TECHNICAL BULLETIN

DATE: 11/02/2009

MD900 (902 CONFIGURATION) PW206E TO PW207E ENGINE CONVERSION MODIFICATION

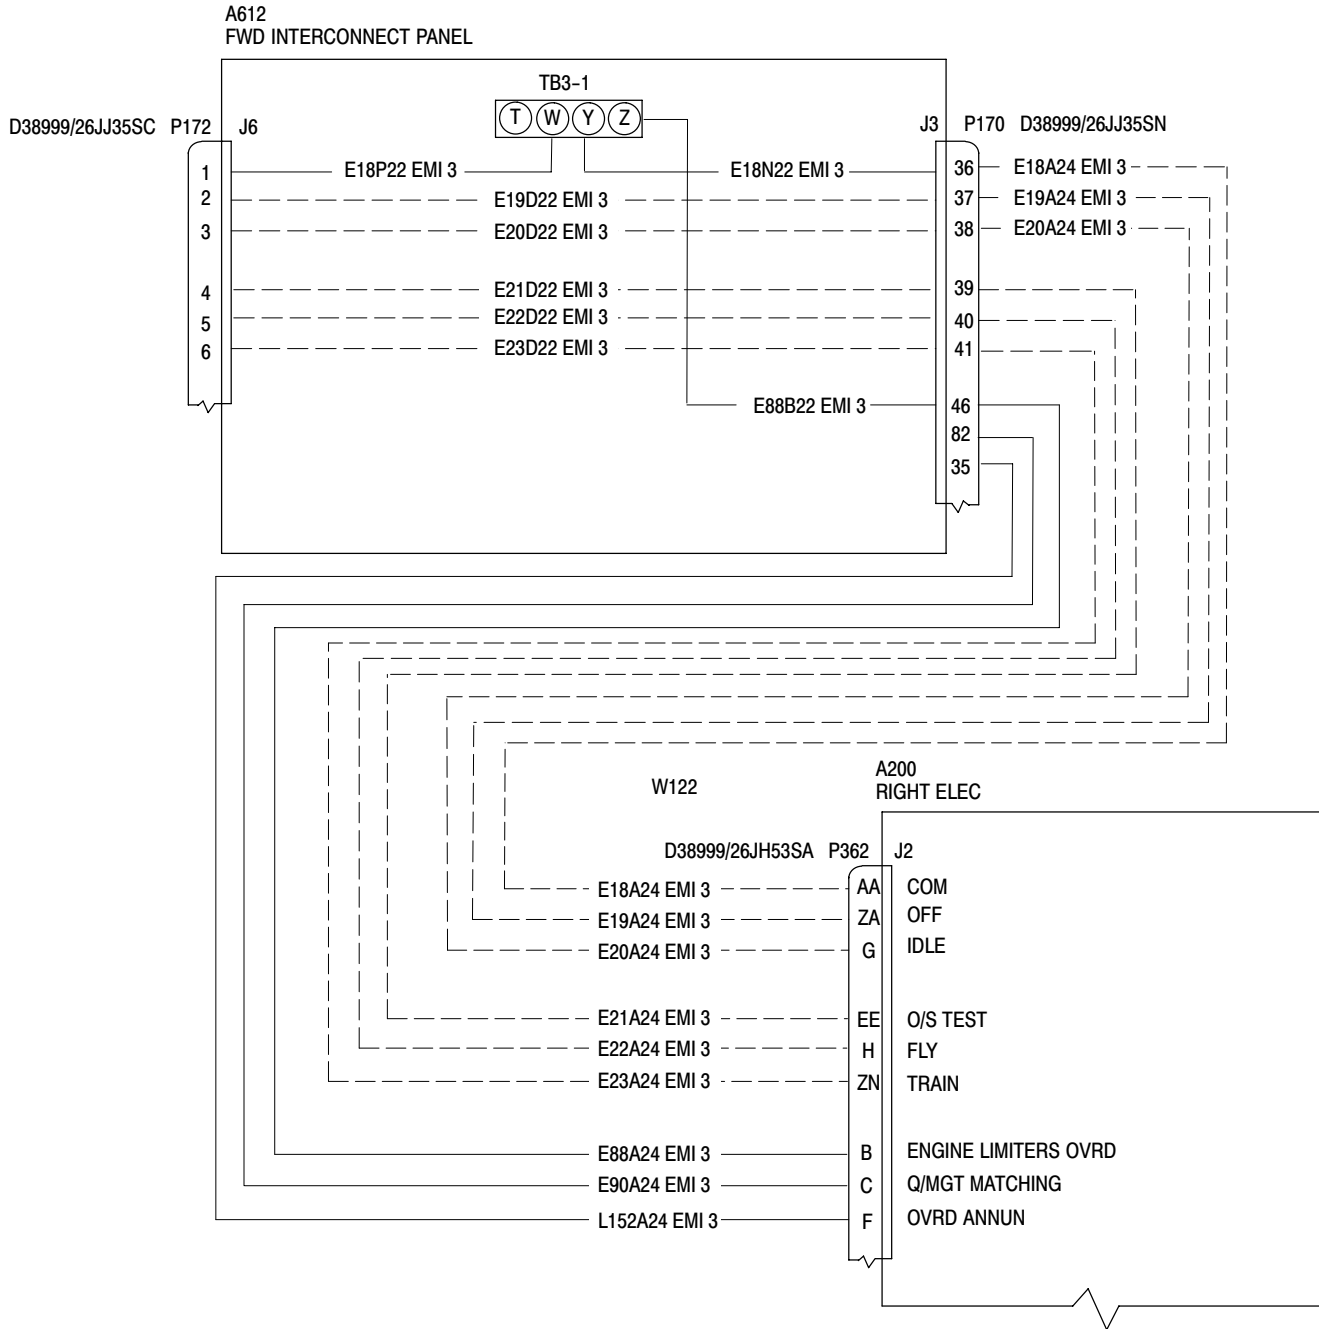
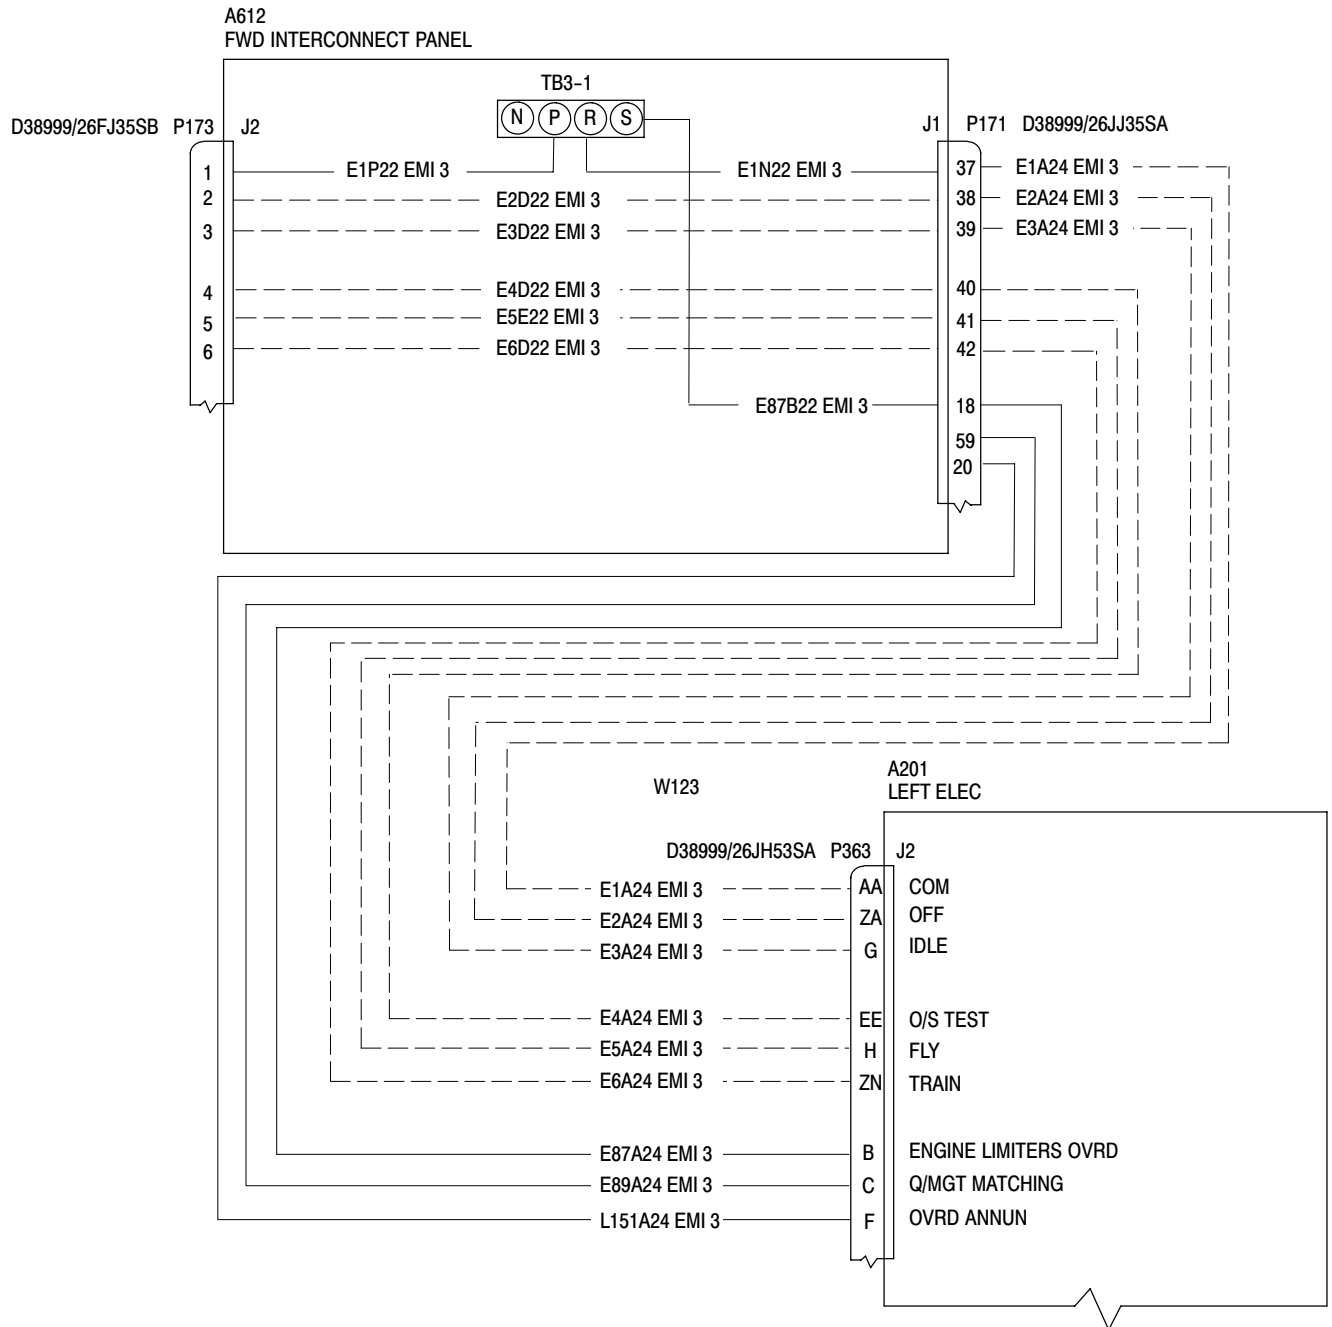
- (c). Assemble wire harness per interconnect drawings pages 8 and 9 with best shop and maintenance practices.(Ref. CSP-900RMM-3, Section 98-30-00, 98-40-00, 98-50-00, and CSP-SPM, Section 20-60-00).

- (h). Wires indicated with dashed lines are installed on baseline aircraft.
